Access Compliance Report

Public Rights-of-Way

Intersection ID: 30236	Main Street: HELMS_RD	Cross Street: LEECREST_DR	Location:	N
ADA ID: A69100F1B035	Ramp Type: BlendTrans1	Initial Pass/Fail: Pass	Overall Compliance: No	Severity Score: 15

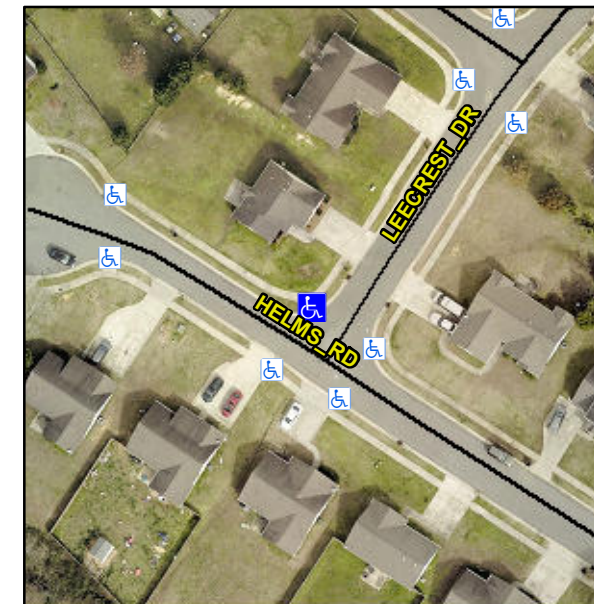
CURB LIP 2.0

R304.2.2-Perp, R304.3.2-Para, R305, R302.7, R304.5.4

Remove & Replace Curb Ramp With Two New Directional Ramps or Equivalent. Remove & Replace Gutter.
